Customer : CU-DAR001 Dart Helicopters Services Drawing Name : HELI UTILITY BASKET LH/RH 350/355  
 Job Number : 37513  
 Estimate Number : 10208  
 P.O. Number : Part Number : D350607043  
 This Issue : 2/20/2008 S.O. No. : Drawing Number : D350-607 REV F P7-9  
 Prsht Rev. : NC Project Number : N/A  
 First Issue : / / Type : LARGE FAB ASSY Drawing Revision : F  
 Previous Run : 37512 Material :  
 Written By : Due Date : 3/15/2008 Qty: 1 Um: Each  
 Checked & Approved By : 080221  
 Comment : Est Rev:E as Per DS19318 06-01-24 JLM  
 Est Rev:F ECN1068 07-12-21 DD verified by:

DESIGN <i>CP</i>	DRAWN BY <i>CP</i>	DART AEROSPACE LTD HAWKESBURY, ONTARIO, CANADA	
CHECKED <i>[Signature]</i>	APPROVED <i>[Signature]</i>	DRAWING NO. DSI 9318	REV. A SHEET 1 OF 1
DATE 06.01.06		TITLE WASHER ADDITION	SCALE NTS
A	06.01.06	NEW ISSUE

## DART SERVICE INSTRUCTION

TO AMEND INSTALLATION INSTRUCTIONS D350-607 REV. F

**Figure 5- Basket Replacement Parts-**  
(D350-607-043 Heli-Utility-Basket™)

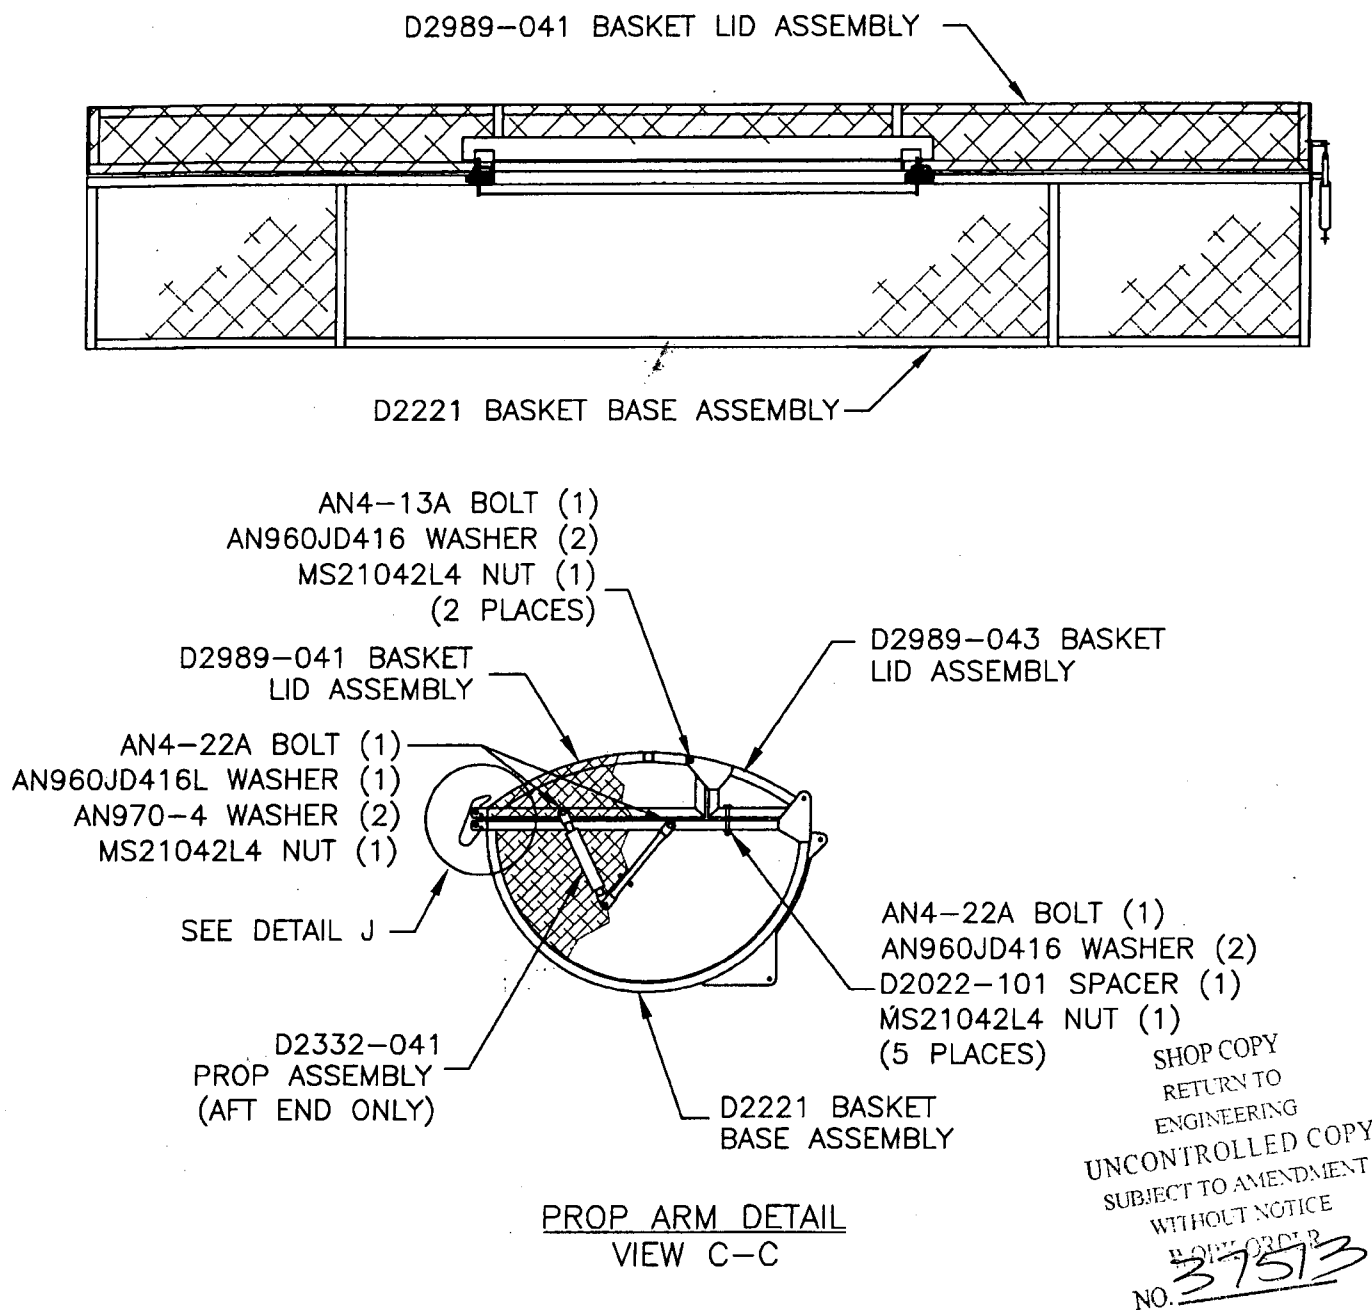
The corrected bolt stackup from Figure 5 of installation instructions D350-607 Rev. F is given below:

AN4-13A BOLT (1)  
AN960JD416 WASHER (1)  
HINGE PLATE (REF)  
**NAS1515H4 WASHER (1)**  
BASKET FRAME (REF)  
AN960JD416 WASHER (1)  
MS21042L4 NUT (1)  
(2 PLACES)

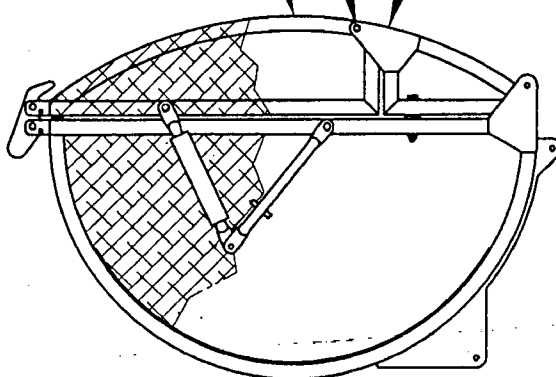
To reduce the possibility of damaging the finish, a **NAS1515H4** washer (2 places) has been added between the hinge plate and basket frame on the **D350-607-043/-047 Heli-Utility-Basket**.
